***RE: Wetland Application, Howard Hale, Construction of Two New Single-Family Homes at 99, 101 & 103 South Beechwood Road, Assessors Map 07.14, Lots 43, 42 and 41, Niantic, Connecticut.***

This office has reviewed the latest set of plans and has the following comments.

99, 101, & 103 SOUTH BEECHWOOD ROAD ~ EAST LYME ~ CT

SHEET  
**C-GD1**  
 SHEET 2 OF 6

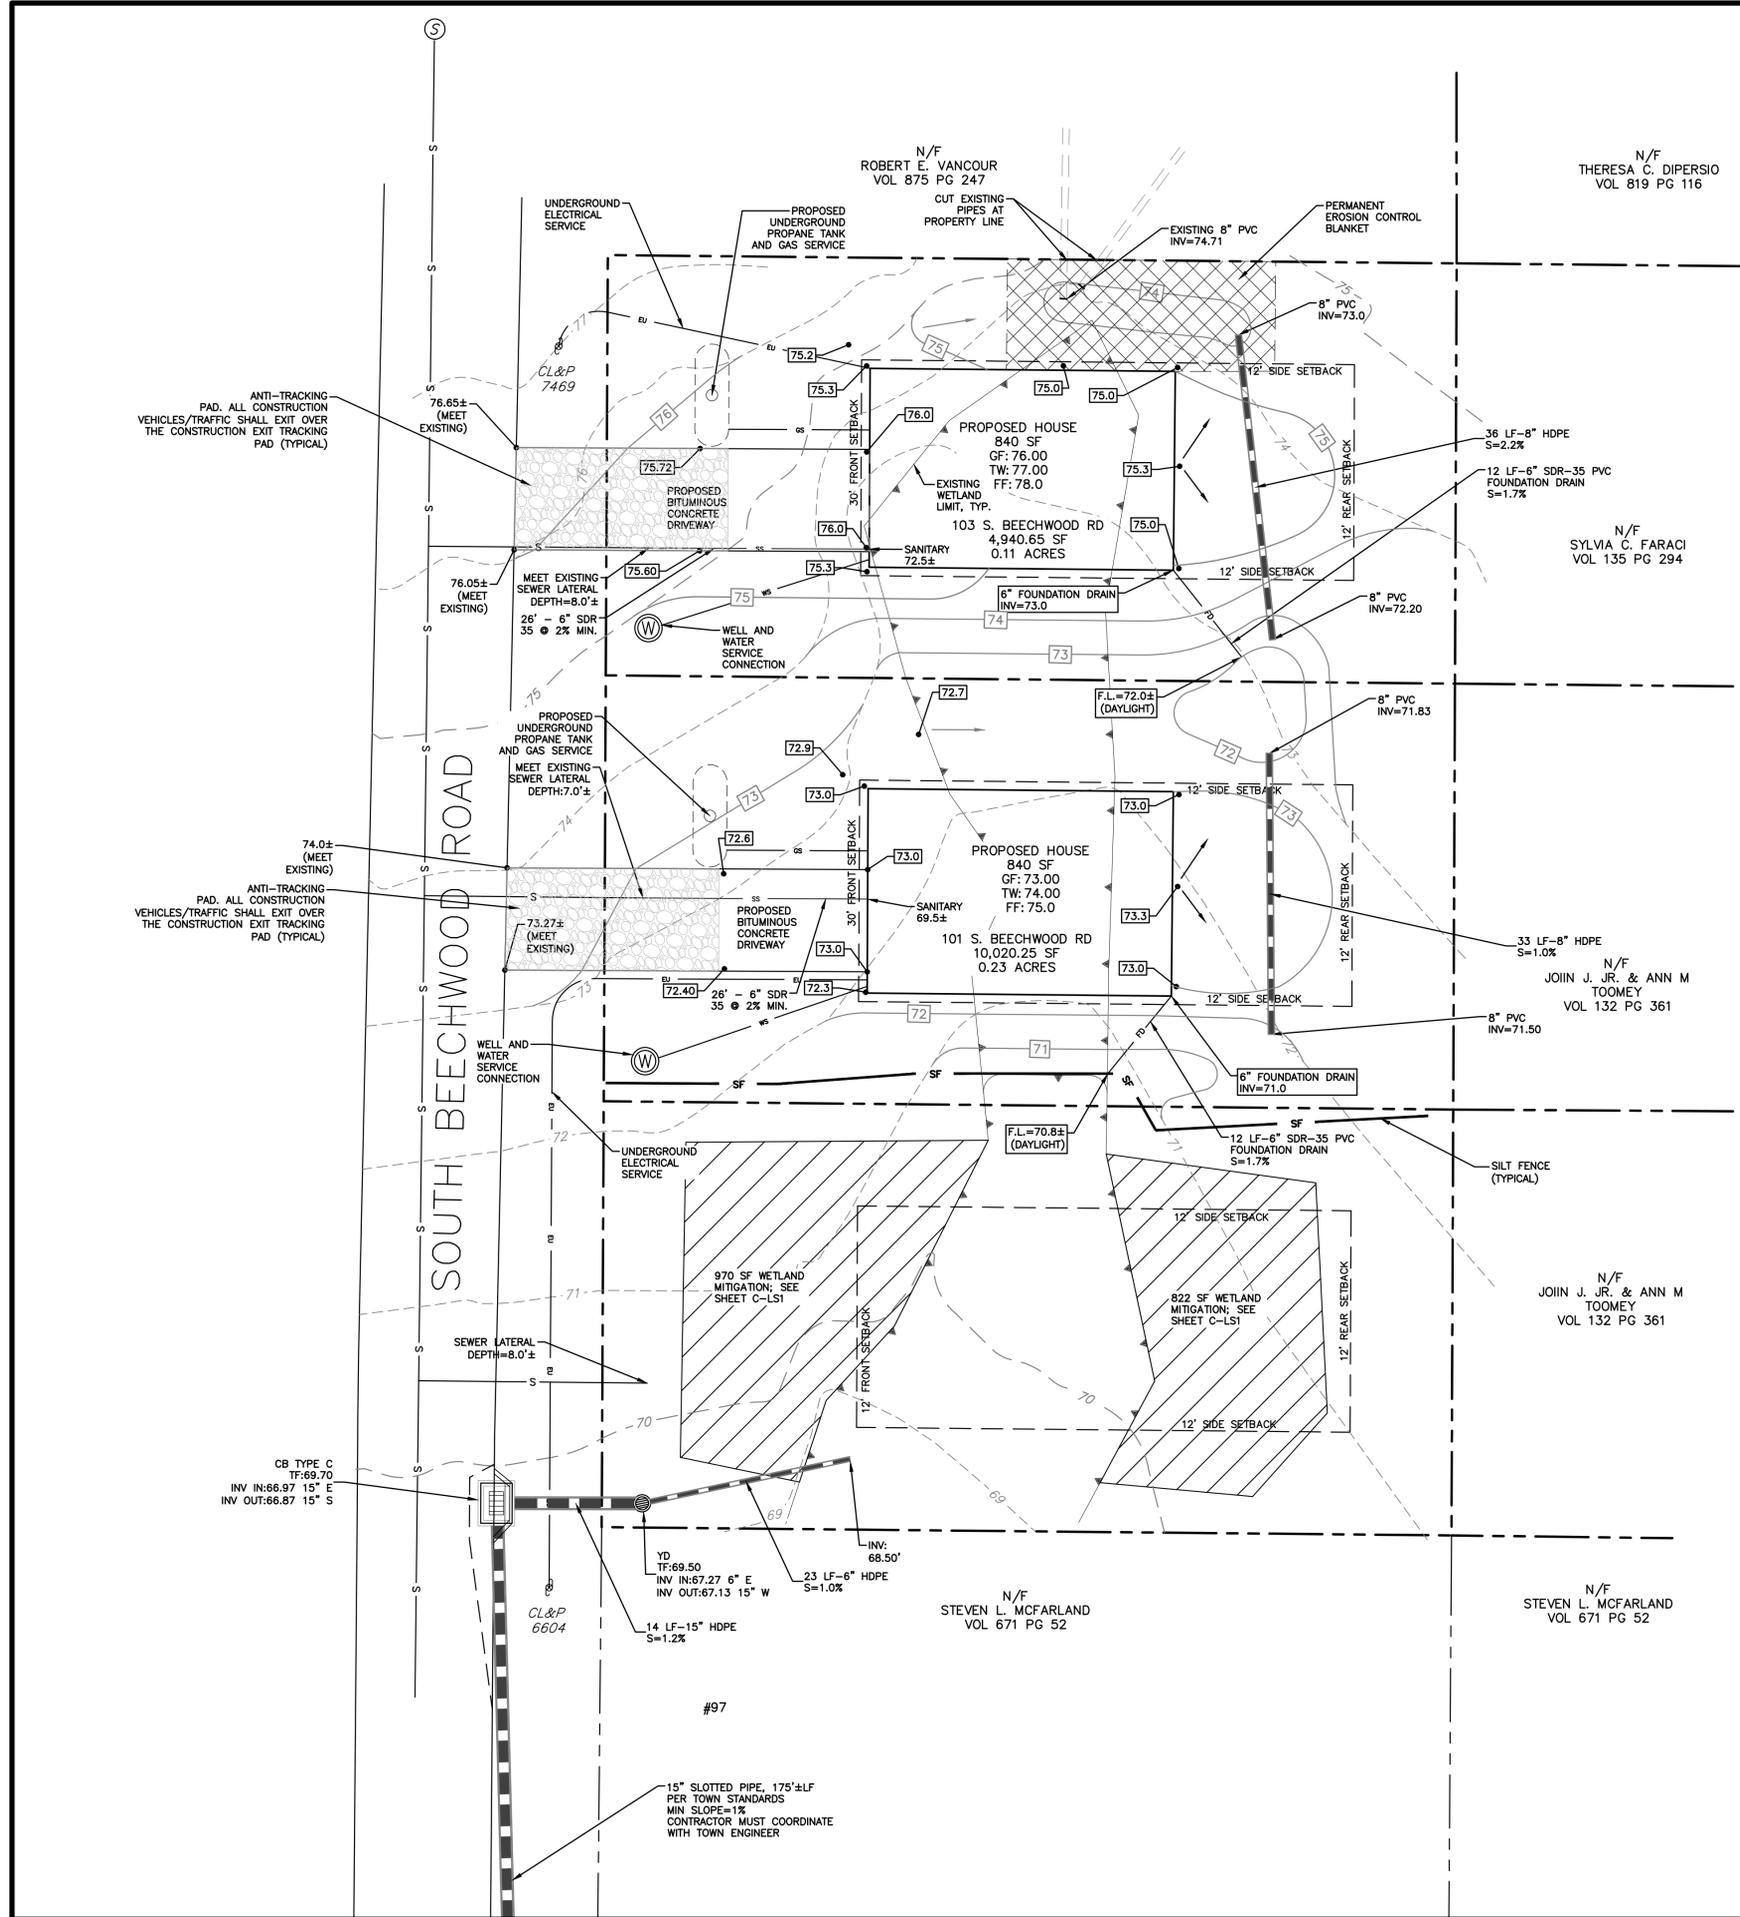
2. The plans shall be updated to include the stormwater pipes and inverts on the "Site layout and Grading Plan"
3. Add a note in a box in Bold with an arrow pointing to the proposed yard drain and 15" HDPE pipe going from the yard drain to the Catch Basin, stating "Yard drain and outlet pipe (even the portion located in the Town Right of Way) are privately owned structures. The Town is not responsible for, and will not, perform any maintenance, repair, or replacement of either of these structures." Place this note on both sheets C-GD1 and C-UT1. This should also be listed as part of the approval.

NO.	DATE	REVISIONS	BY
1	8/3/2021	REVISE PER TOWN ENGINEER COMMENTS	GMM
